**Planning Commission Agenda
Wednesday August 9, 2023 – 6:30 PM
Minturn Town Hall / Council Chambers
302 Pine St Minturn, CO**

To: Planning Commission
From: Madison Harris, Planner I
Date: August 4, 2023
Re: 962 Main Street - Changes to Approved Plans

Final Plan Review for New Driveway

SOUTH MINTURN ESTATES LOT 2 SEWER, WATER & GRADING PLANS MINTURN, COLORADO JUNE, 2022

SHEET
C-4

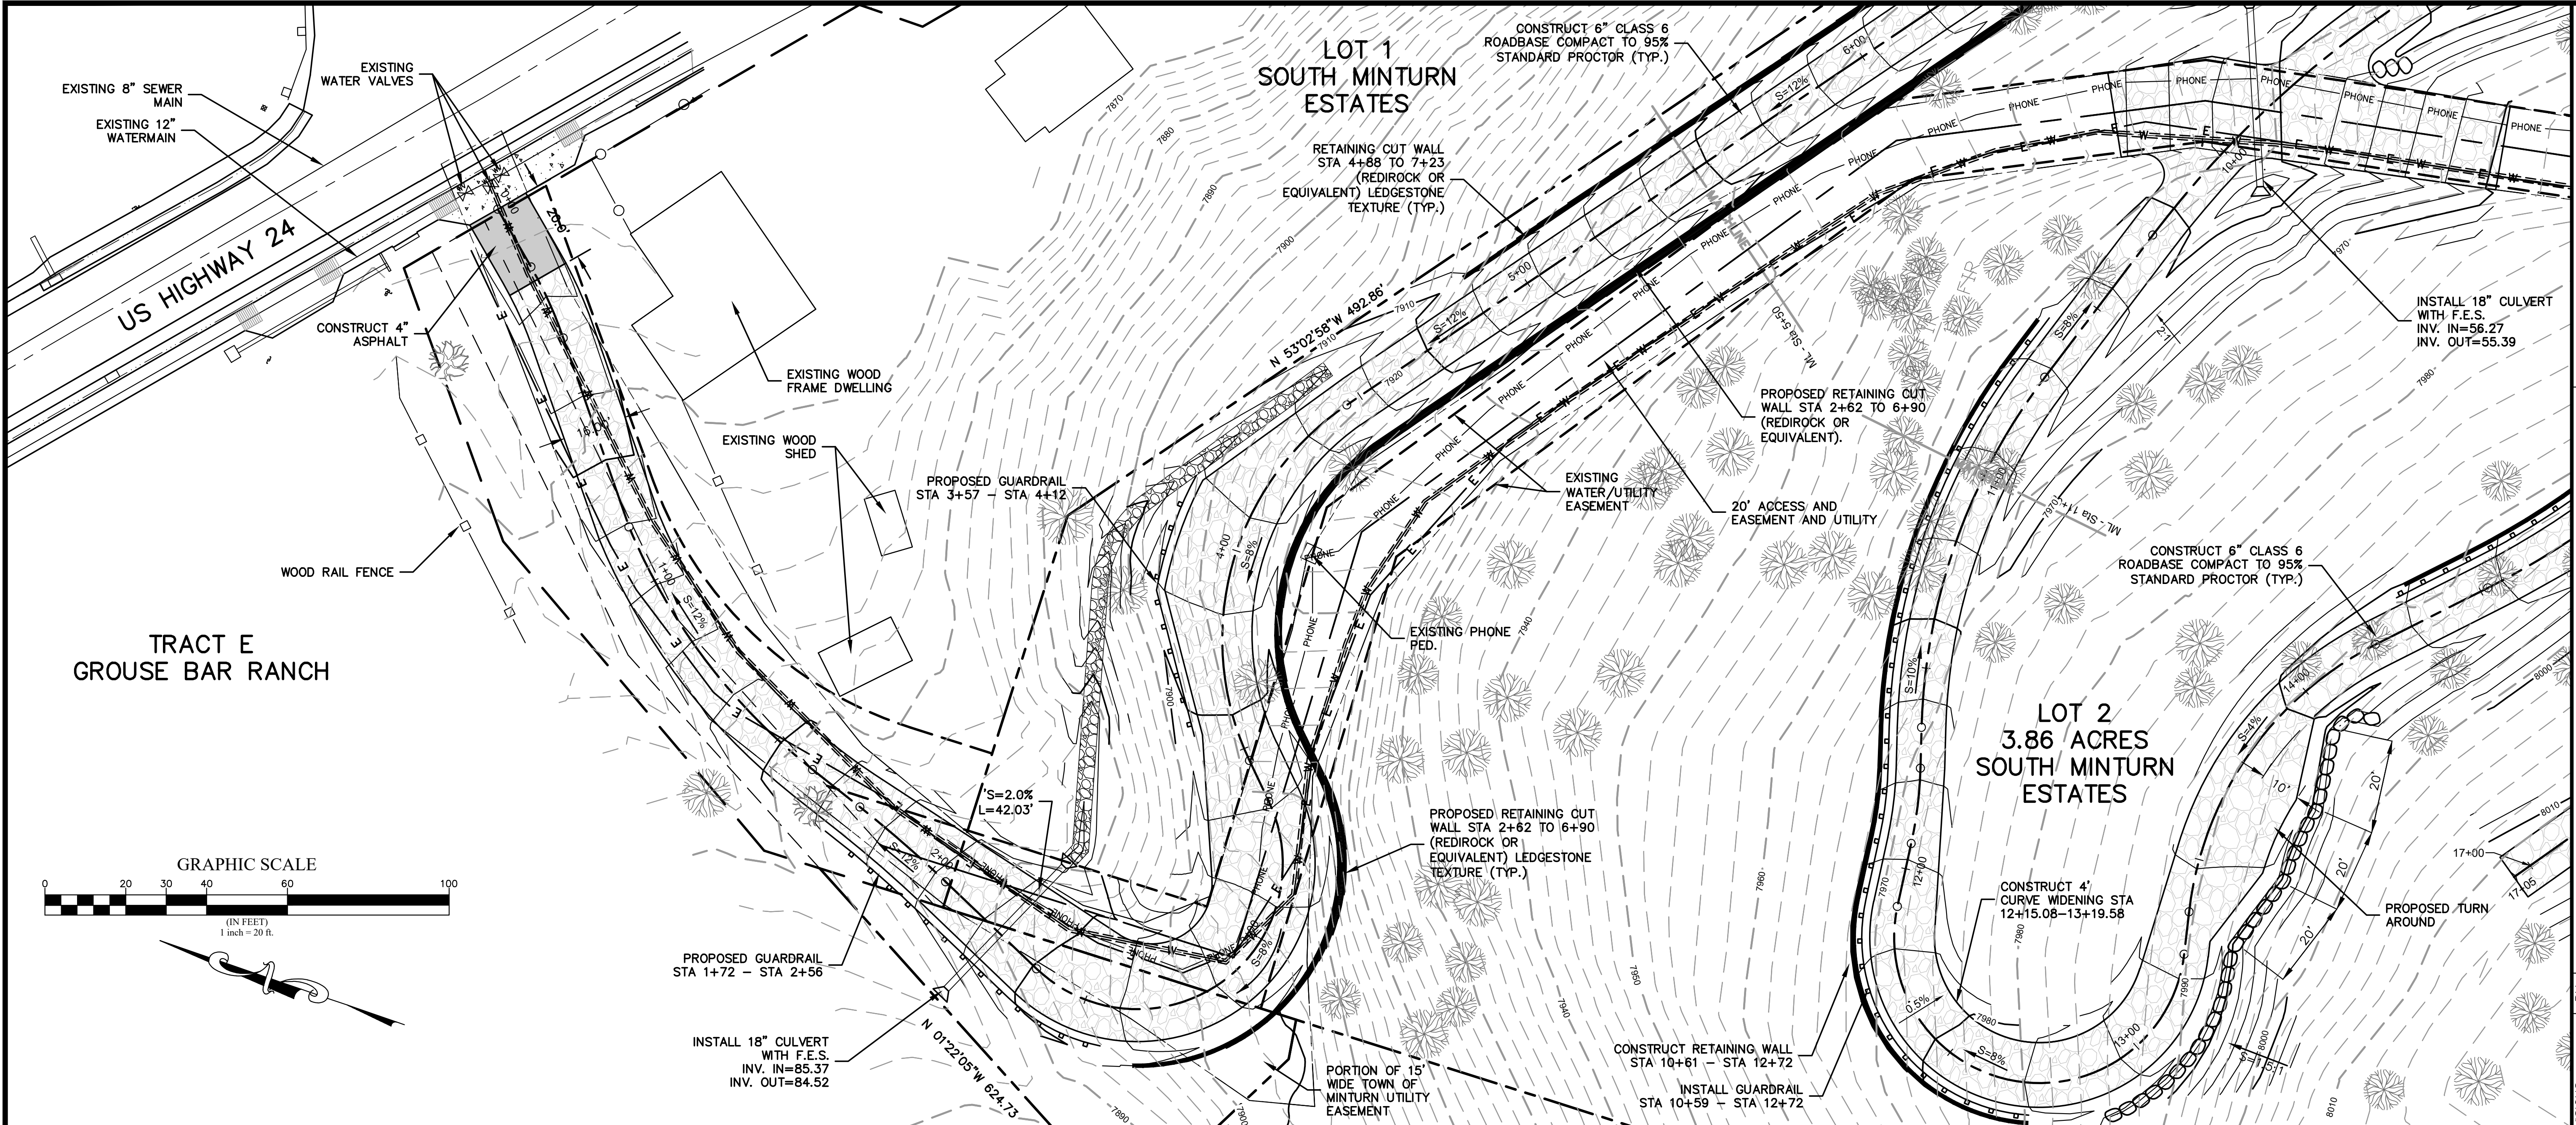
- f. Driveways and parking areas. Indicate finished surface, heated or unheated, grade, percent slope, dimensions, turning radii and spot elevations at the property line. **See sheet C-4**

- i. Sheet C-4 includes the note “Widen road 5’ for town dump truck turning”. Please show the extents of the widening.
 - b. Near the intersection of the water tank road there is a turn out, road widening, and a short northerly extension of the existing tank road. We suggest reviewing to

Driveways and parking will be submitted at building permit process. The driveway finish surface will be 6” class 6 roadbase and will not be heated. Please see sheet C4-C8 for grades, percent of slope, dimensions, and spot Elevations. Please see sheet C-3 for geometric radii and other horizontal data.

- c. Please provide grading detail at the inside of the curve at Sta 3+00. The plan currently notes “Grade to Drain” **We graded out a ditch and provided riprap. Please see sheet C-4.**

SHEET C-10

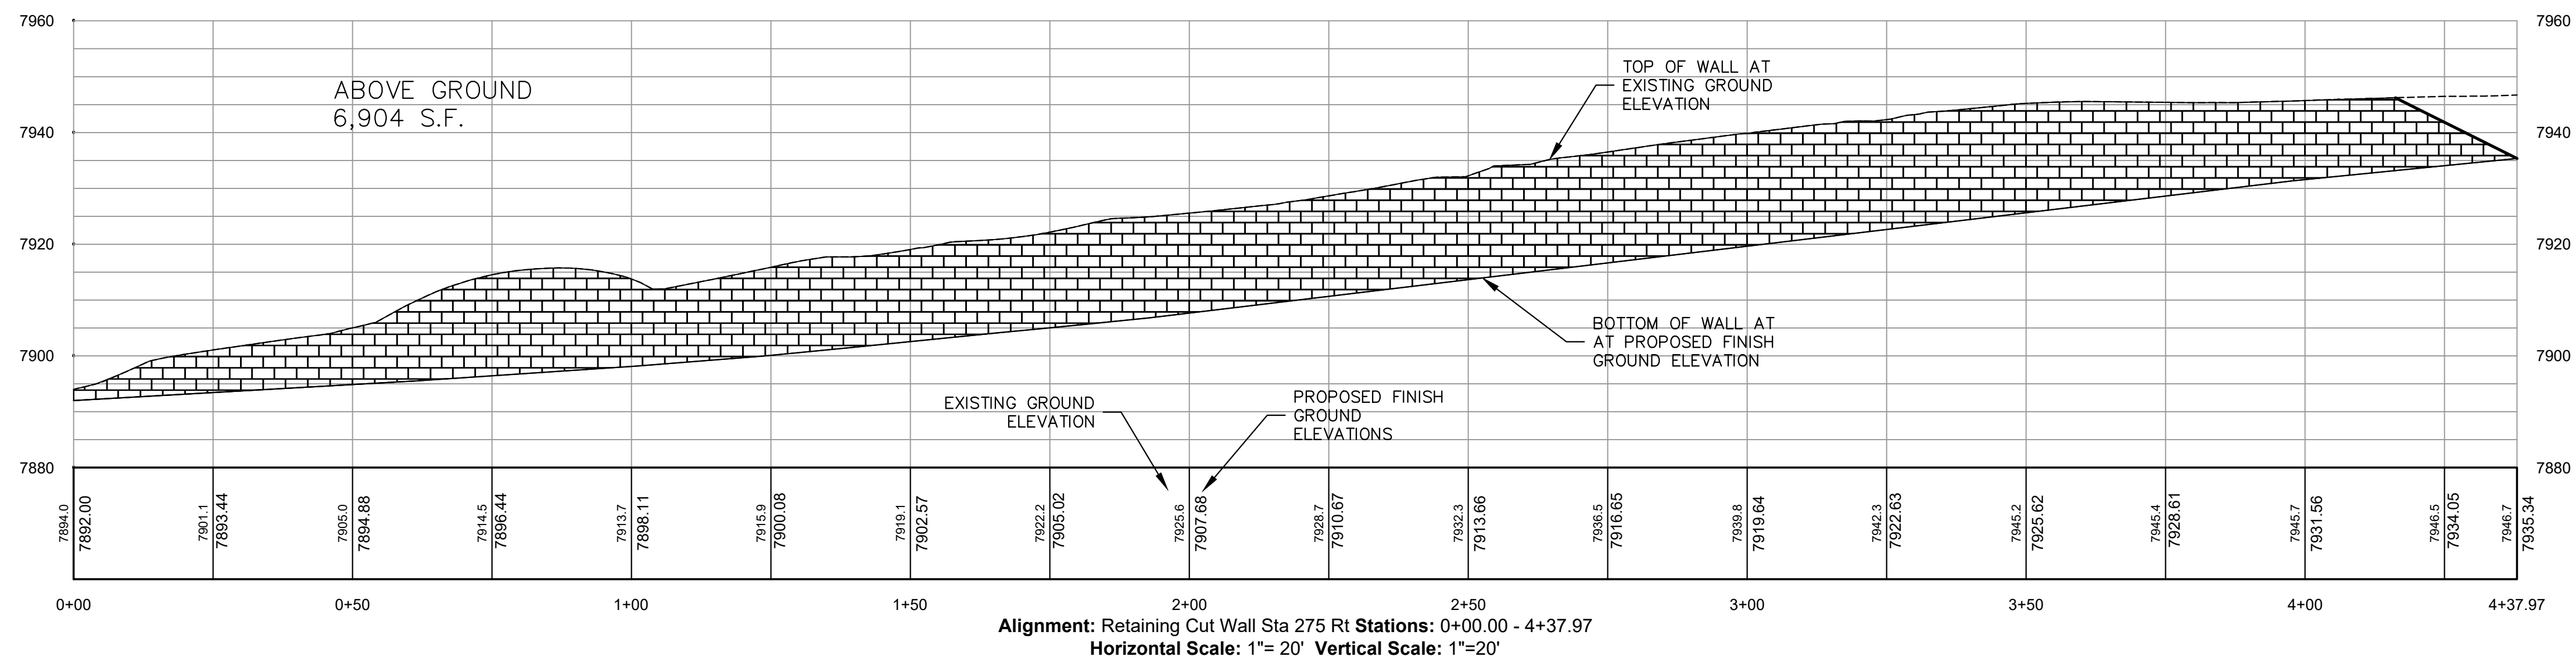
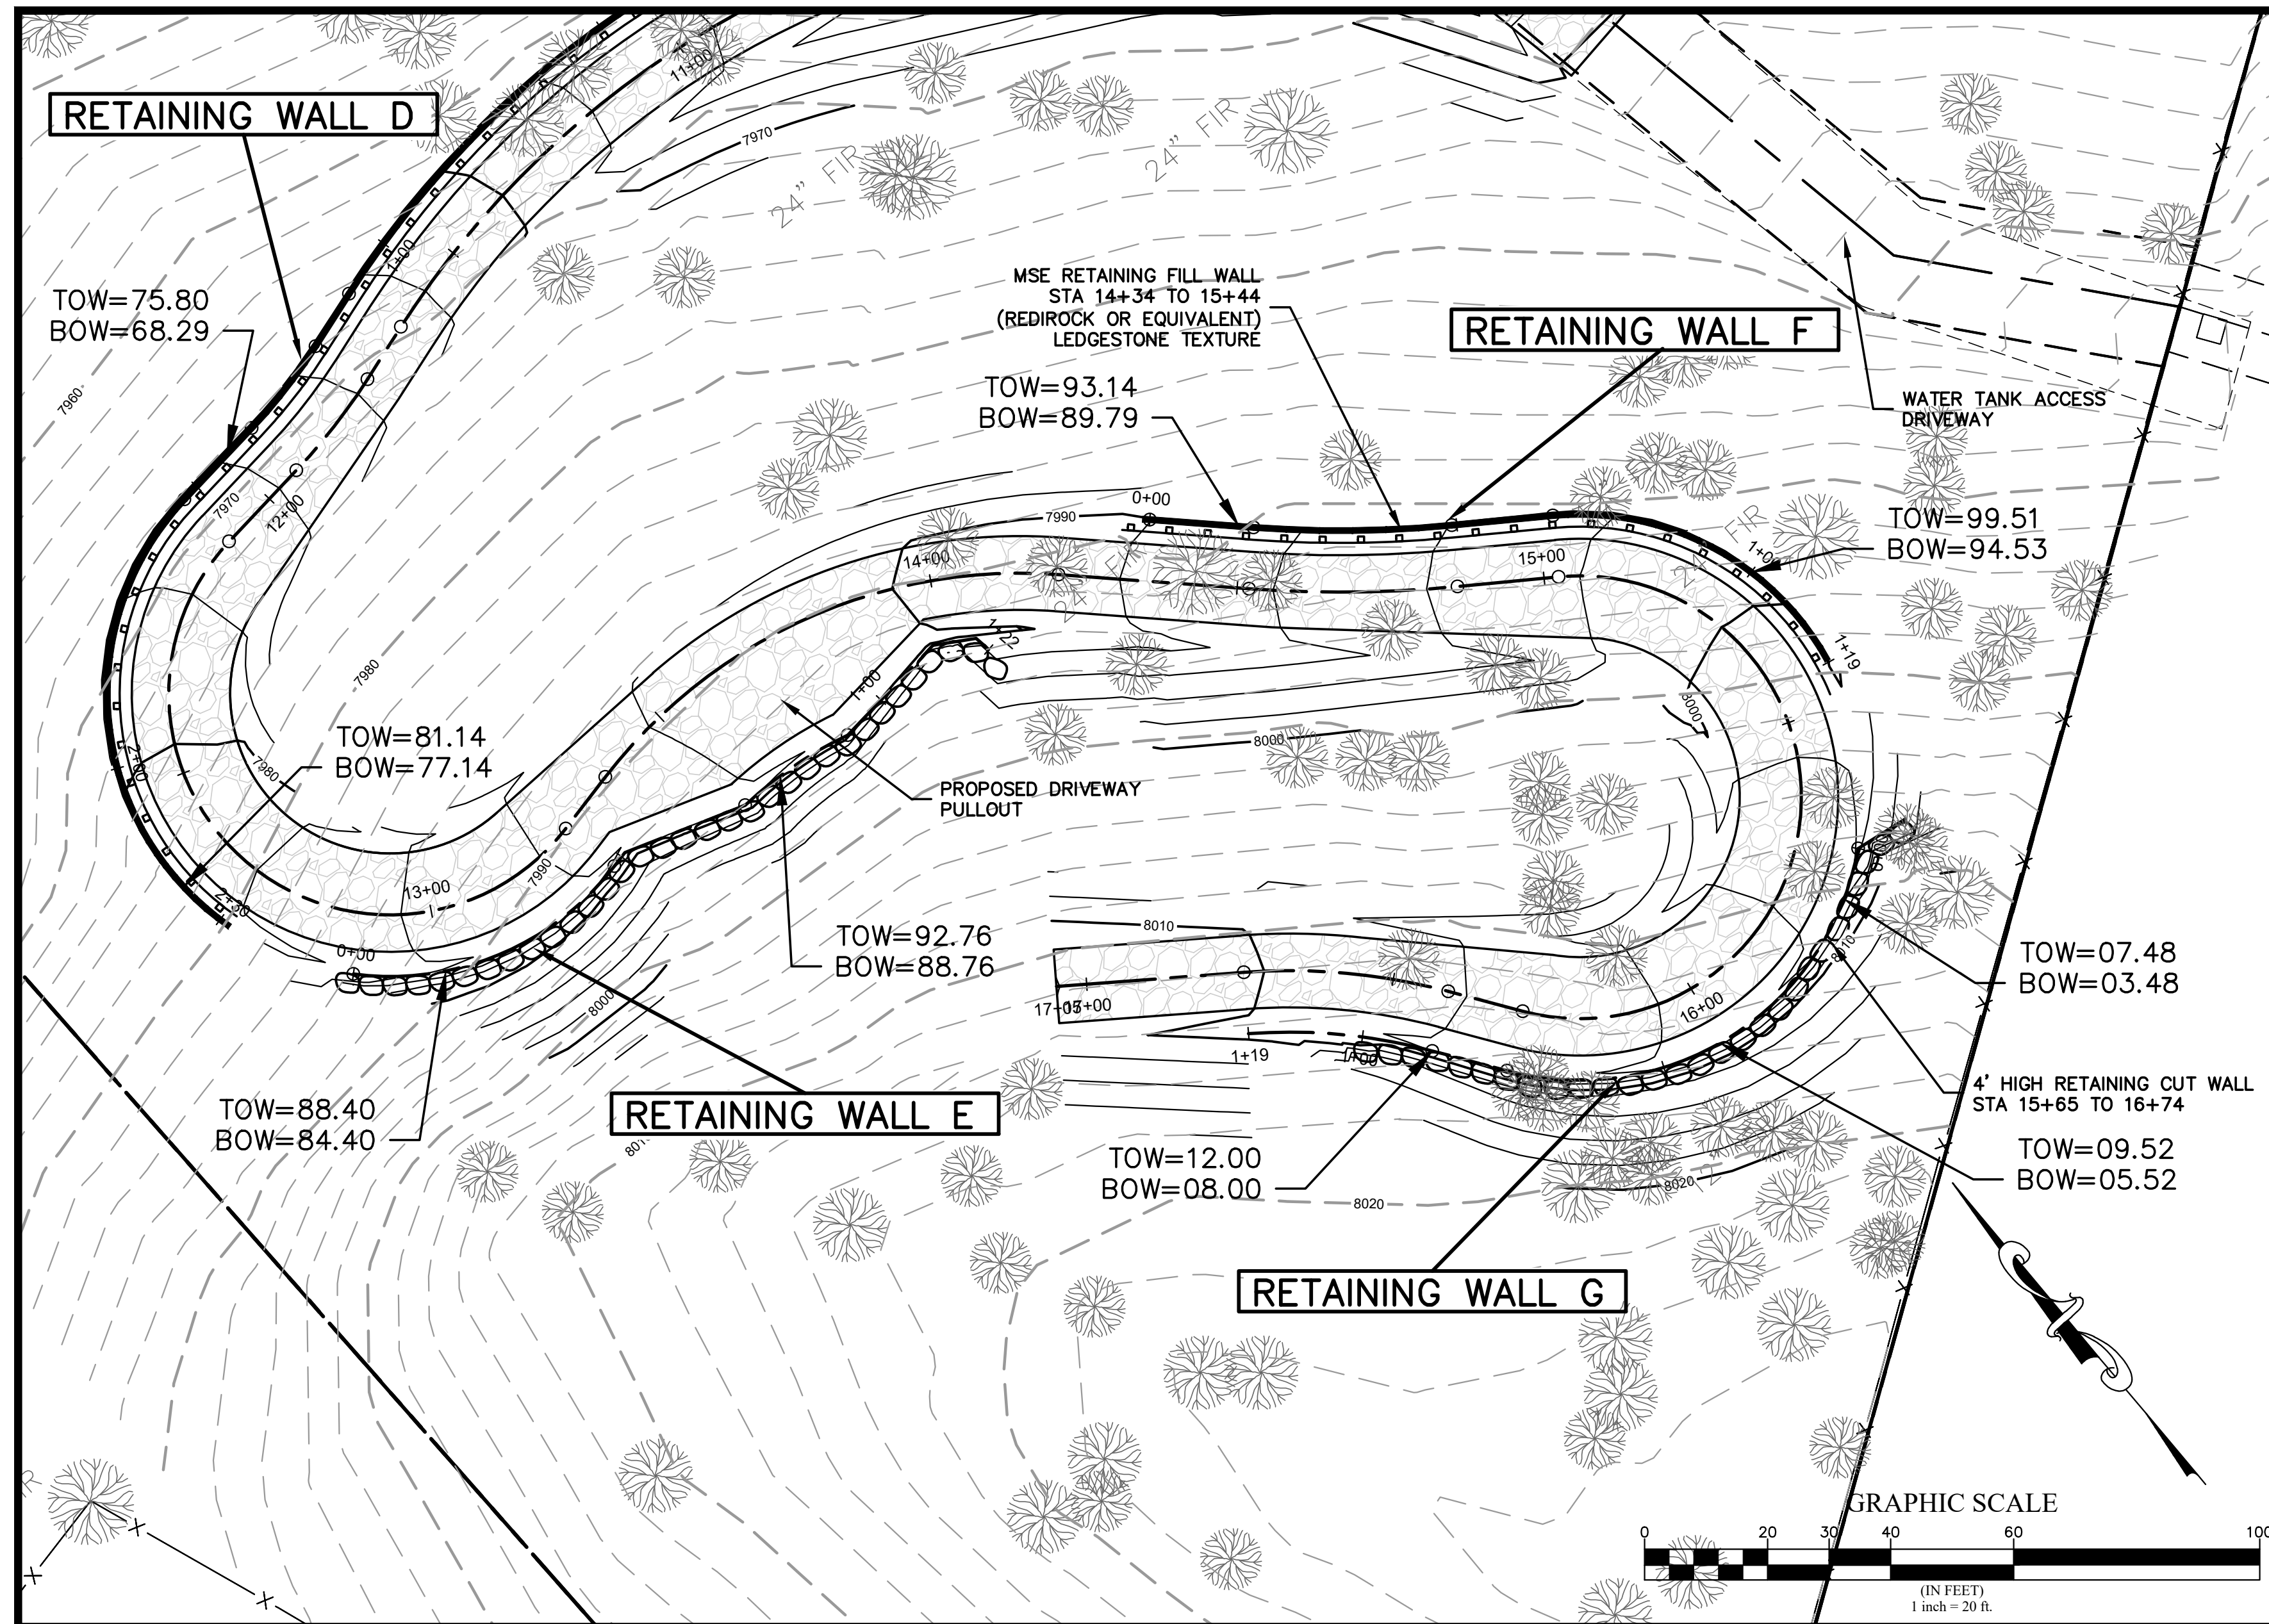
- i. Existing and proposed retaining walls (including materials). **See sheet C-10 – C-13**
 - Retaining walls are proposed to be constructed with boulders and/or “Redi-Rock.” Redi Rock are large stacked concrete blocks. The proposed finish on the exposed surface is “Ledgestone.”

SHEET C-20

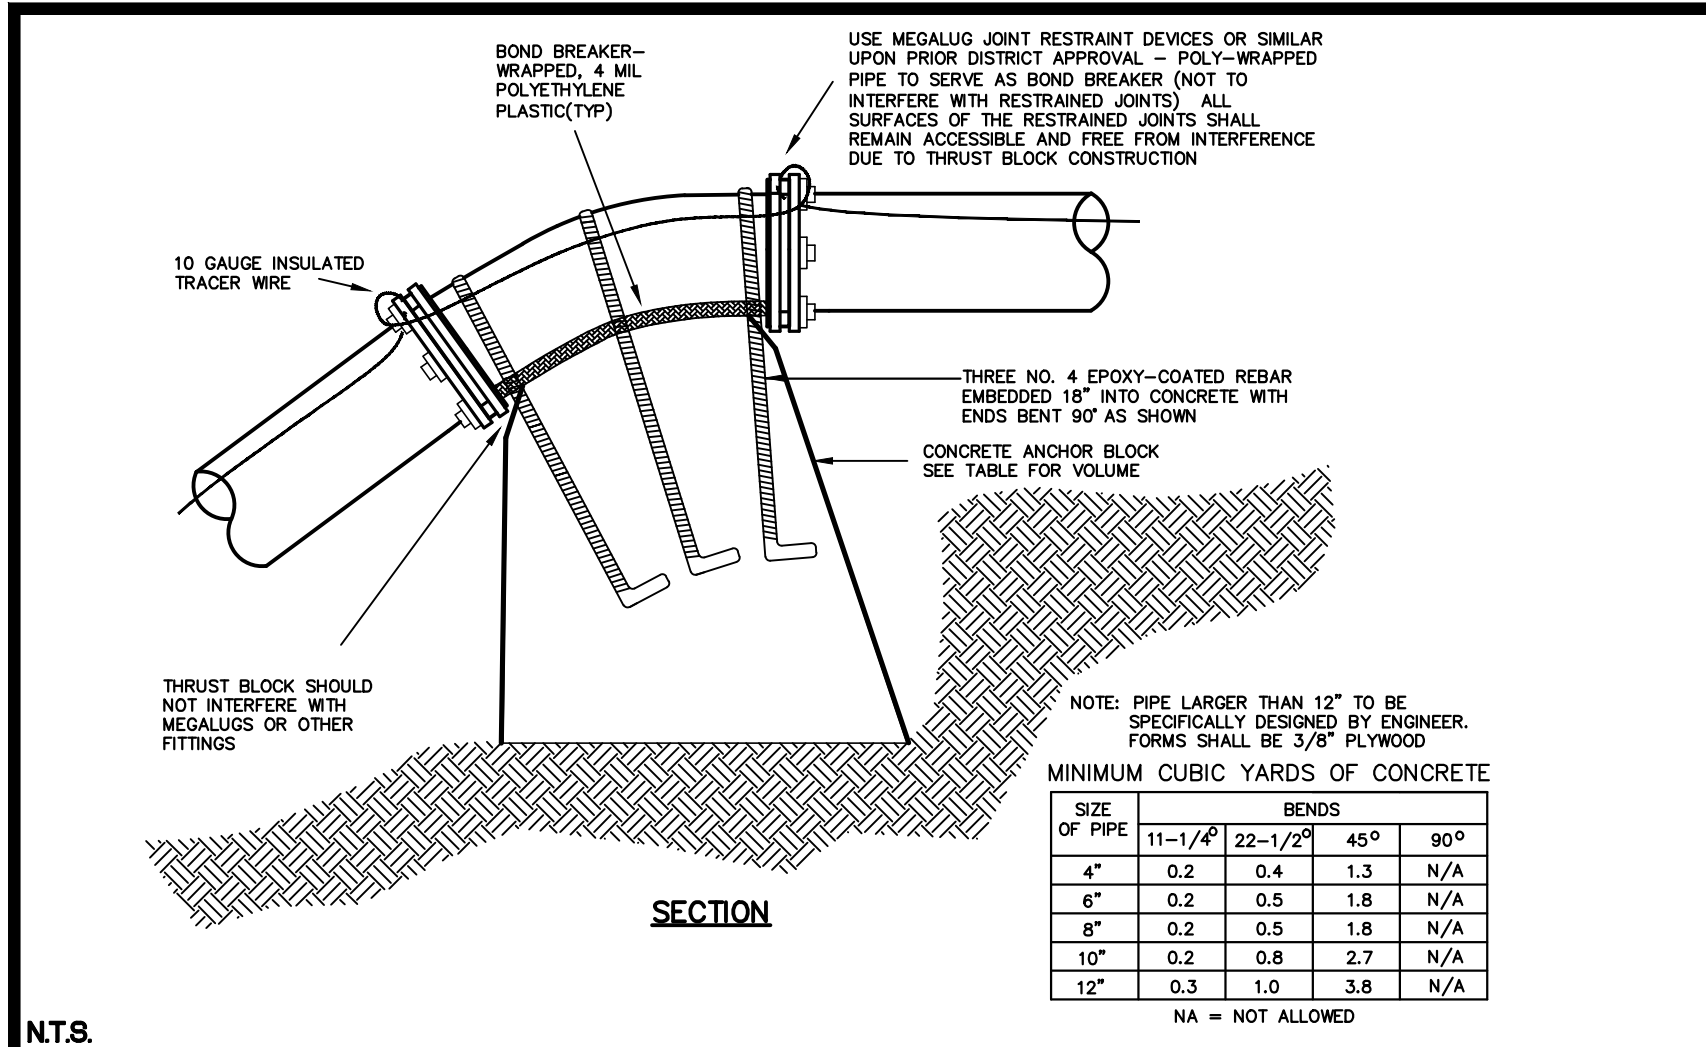
- a. The culvert crossing at the tank road intersection drains onto a steep (1.5:1) embankment. Please provide erosion control details. **We will be providing riprap and an erosion control blanket to stabilize the 1.5:1 slope (see sheet C-20).**
